Access Compliance Report

Public Rights-of-Way

(Curb Ramps)

Intersection ID: 3559	Main Street: PERIMETER_PY	Cross Street: W_W_T_HARRIS_BV	Location: SE
ADA ID: D0C2B037BFF6	Ramp Type: Perp	Initial Pass/Fail: Fail	Overall Compliance: No
Severity Score: 13.75			
Codes/Mitigation Info/Possible Solution		Field Measurements/Component Compliance

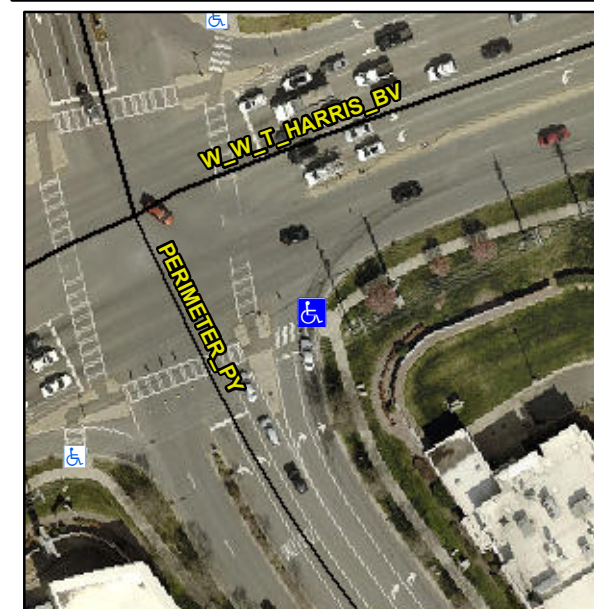
Not Found, R304.2.2

Compliance	Description	Data	Compliance	Description	Data
N/A	Ramp Length (in)	59.0	No	Ramp Slope (%)	8.4
Yes	Ramp Width (in)	48.0	Yes	Ramp XSlope (%)	2.7
N/A	Flare Type LT	N/A	N/A	Flare Type RT	N/A
N/A	Flare Slope LT (%)	N/A	N/A	Flare Slope RT (%)	N/A
N/A	Flare Traversable LT?	N/A	N/A	Flare Traversable RT?	N/A
N/A	Landing Length (in)	N/A	N/A	DWS Provided?	N/A
N/A	Landing Width (in)	N/A	N/A	DWS Contrast?	N/A
N/A	Landing Slope (%)	N/A	N/A	DWS Length (in)	N/A
N/A	Landing X Slope (%)	N/A	N/A	DWS Full Width?	N/A
N/A	Landing Curb? (Y/N)	N/A	N/A	DWS Offset (in)	N/A
N/A	Shared Landing?	N/A			
N/A	Gutter Ponding?	N/A	N/A	Gutter Slope (%)	N/A
N/A	Gutter Lip Ht (in)	N/A	N/A	Gutter X Slope (%)	N/A
N/A	Painted X Walk1?	Yes	N/A	Painted X Walk2?	N/A
	X Walk 1 Direction	To NW		X Walk 2 Direction	N/A
N/A	X Walk 1 Width (in)	120.0	N/A	X Walk 2 Width (in)	N/A
	X Walk 1 Slope (%)	1.3		X Walk 2 Slope (%)	N/A
	X Walk 1 X Slope (%)	4.2		X Walk 2 X Slope (%)	N/A

Remove & Replace Entire Ramp.
